JRPP No	2011SYW010
DA Number	15/2011/DA-RA
Local Government Area	Campbelltown City Council
Proposed Development	Construction of a 6 to 8 storey mixed use commercial, retail and residential apartment development with 2 levels of basement car parking spaces
Capital Investment Value	\$28,261,000
JRPP Referral Criteria	Development exceeds \$10 million capital investment value
Street Address	Lot 3004 Stowe Avenue, Campbelltown
Applicant	Blue CHP Limited
Number of Submissions	48 - Including 19 individual objections, 27 form letters objecting to the proposal, two objections from Campbelltown City Council and 1 submission in support of the development
Recommendation	Refusal
Report by	Rad Blagojevic – Senior Development Planner

Purpose

The purpose of this report is to assist the Sydney West Joint Regional Planning Panel in its determination of the subject development application pursuant to the *Environmental Planning and Assessment Act 1979*.

Figure 3: Height Controls within Macarthur Regional Centre Master Plan

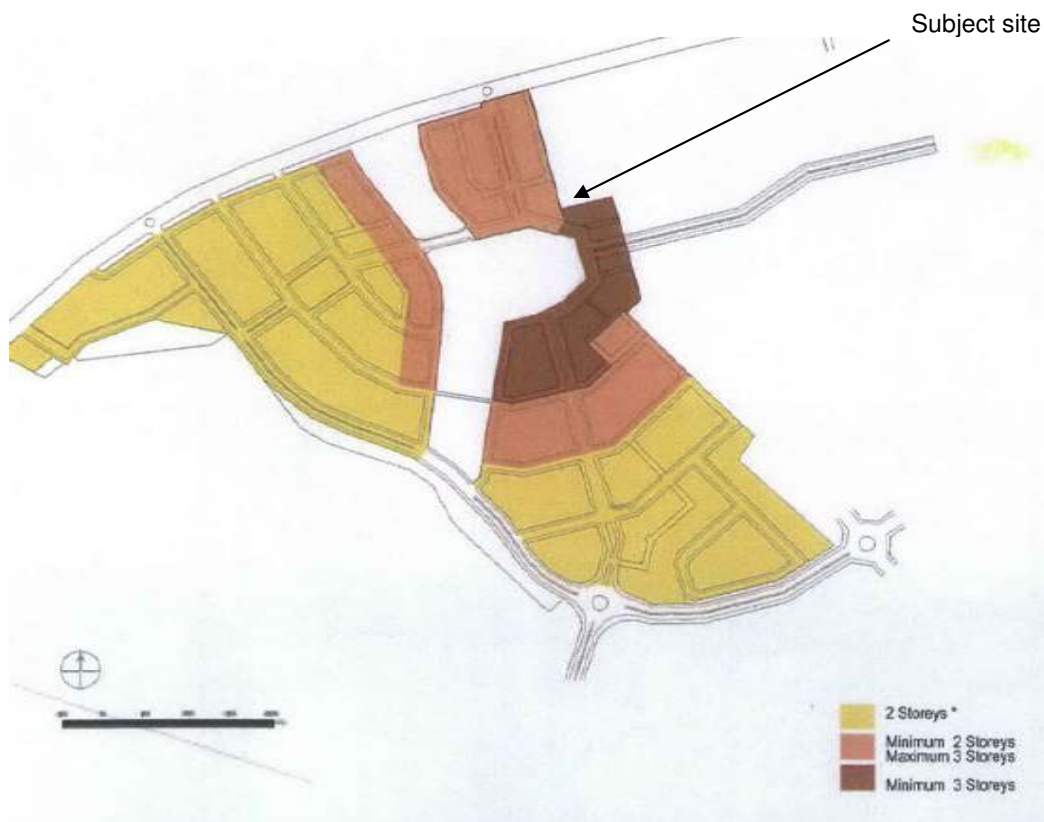
The Master Plan provides design controls that include height controls. The subject site is identified in the master plan as having being suitable for two building heights that are:

- Northern part of the site up to 3 storeys; and
- Southern part of the site a minimum 3 storeys and a maximum of 8 storeys (or 27 metres).

The proposal partially complies with the Master Plan in this regard.

Concerns have been raised about the development's non-compliance with height recommendations contained within the master plan. The proposed development has a 7 storey building on land that envisaged a maximum height of 3 stories (northern portion of site).
